SERVICE BULLETIN

NACELLE - EXHAUST - BLOCKER DOORS, THRUST REVERSER - INSPECTION/REPAIR

January 13, 1998

V2500-NAC-78-0147

Thrust Reverser Blocker Door Inspection
Figure 1

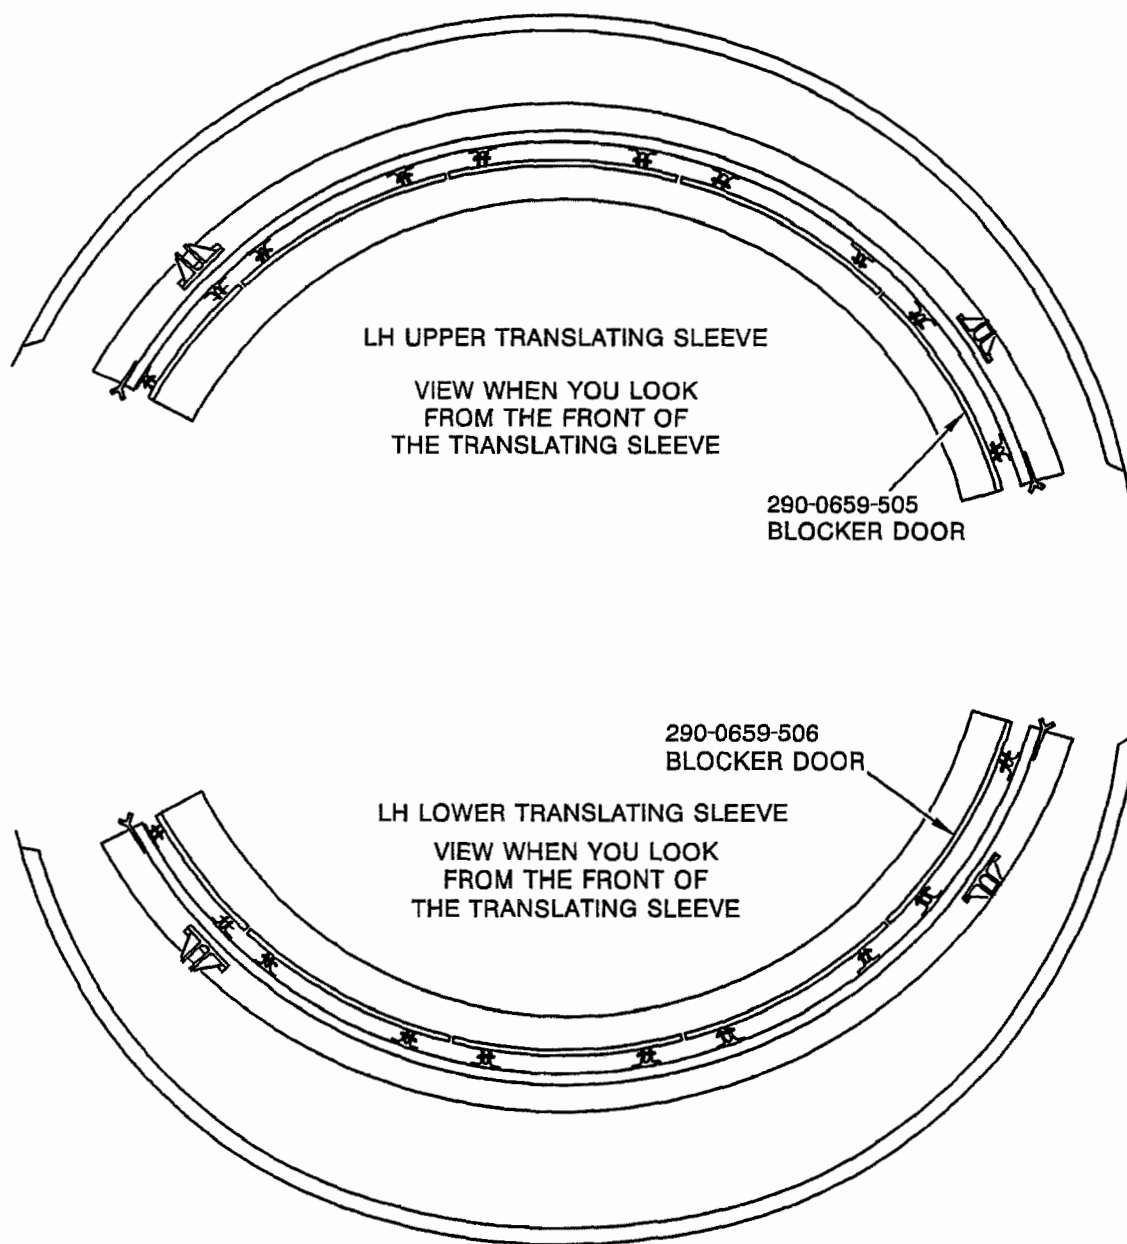
B. Examine the identification markings on all 290-0659-505 and 290-0659-506 blocker doors (including spare blocker doors). Refer to Figures 1 and 2.

(1) If the blocker door is marked with a date before 11/01/96, and has the name "NC Dynamics" near the assembly part number, you must remove and install the spring as instructed in paragraph C.

(2) If the blocker door markings are other than in (1), no further action is required.

Thrust Reverser Blocker Door Spring Removal/Installation
Figure 3

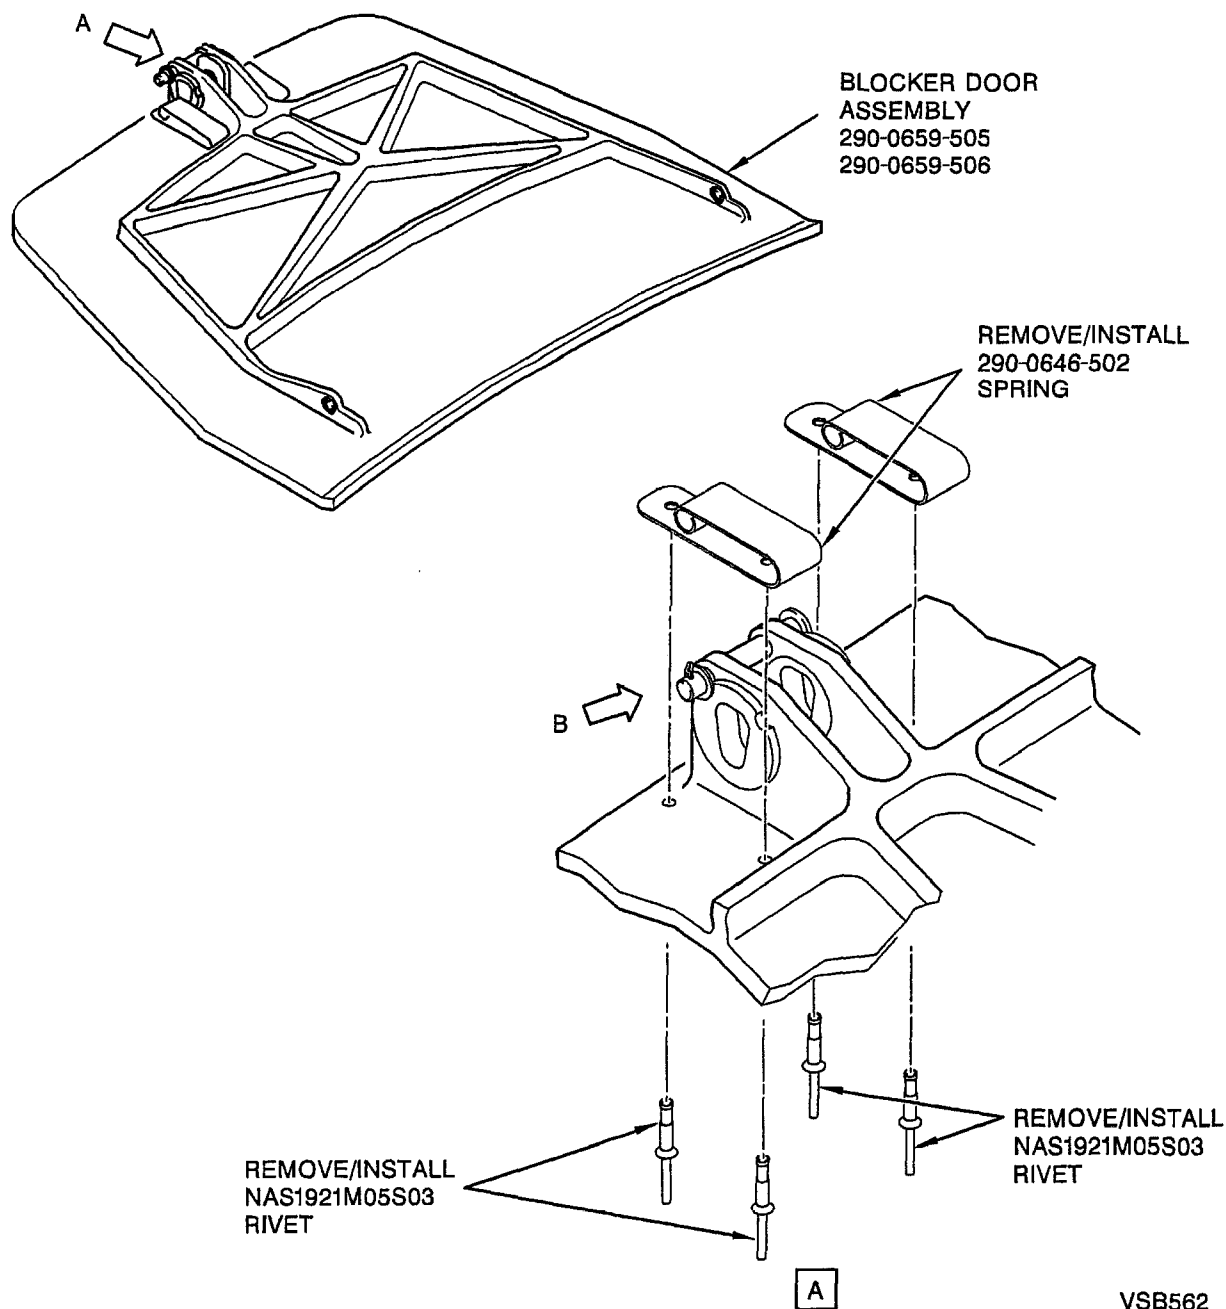
C. Remove and re-install the blocker door springs. Refer to Figure 3.

(2) Remove the rivets and the springs from the blocker door. Do not make the rivet holes larger.

- (3) Mix the primer converter (CoMat 07-115), thinner (CoMat 07-116), and primer base (CoMat 08-039). Refer to the manufacturer's instructions.
- (4) Install the springs on the blocker door with the NAS1921M05S03 rivets. Wet install the rivets with the primer mix. Wipe off any unwanted primer with a lint free cloth (CoMat 02-099) and solvent (01-438).
- (5) If necessary, install the blocker door on the thrust reverser. Refer to the MD-90 Aircraft Maintenance Manual, Chapter 78-32-20, Page block 401.
